Determination 2024/042

Regarding the compliance of external timber wall cladding

107a Main Road, Fairfield, Dunedin

Figure 1: View of underside of cladding, west elevation

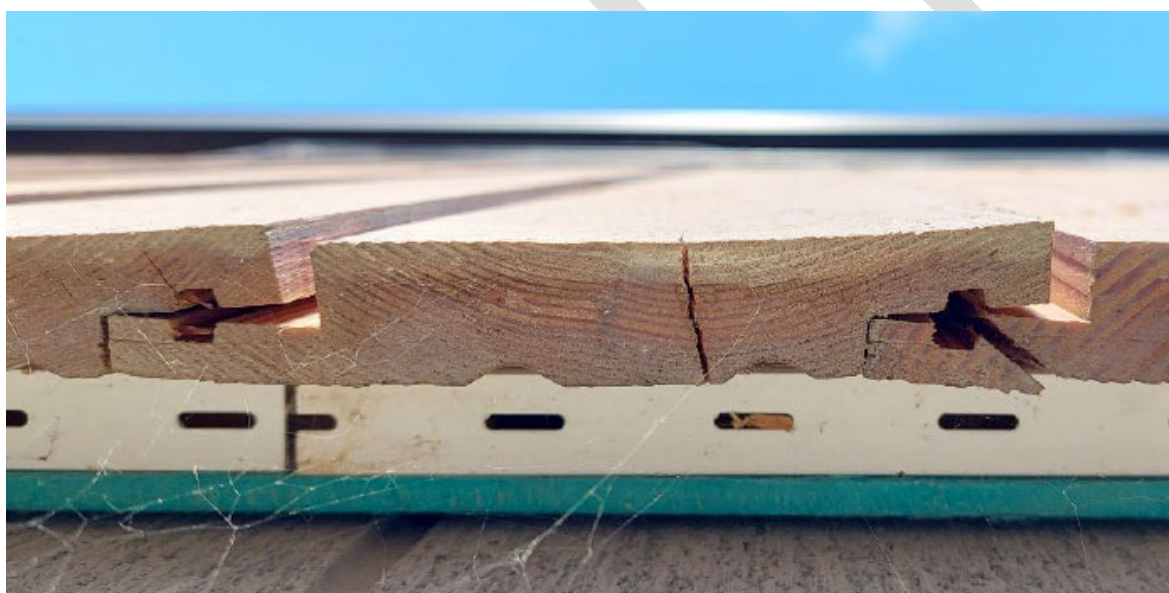
- 1.2.4. C Cockburn, the second LBP who carried out the installation of the wall cladding (“the second LBP’).
- 1.3. This determination arises from defects to the external vertical shiplap timber wall cladding (“**the cladding**”) installed on the dwelling at 107a Main Road, Fairfield, Dunedin, pursuant to building consent ABA-2020-1331. Refer to figure 1.²

- cupping⁹ and delamination of the weatherboards
 - long cracks and splits on the edges and down the centre of the boards, with some extending through the full thickness of the weatherboard

- knots with splits and holes wider than 2mm, bark and resin pockets in the wood, loose and missing knots, and some holes that extend through the weatherboards

- the construction of the external corners did not comply with the building consent documentation, there are cracks and splitting in the butt joints, and incorrect type and location of the fixings used.

4.13. Accordingly, I conclude the as-built external wall cladding does not comply with Building Code clauses B2 and E2.

5.1. In accordance with section 188 of the Building Act 2004, I determine the cladding at 107a Main Road, Fairfield, Dunedin, does not comply with Building Code clauses B2 and E2.
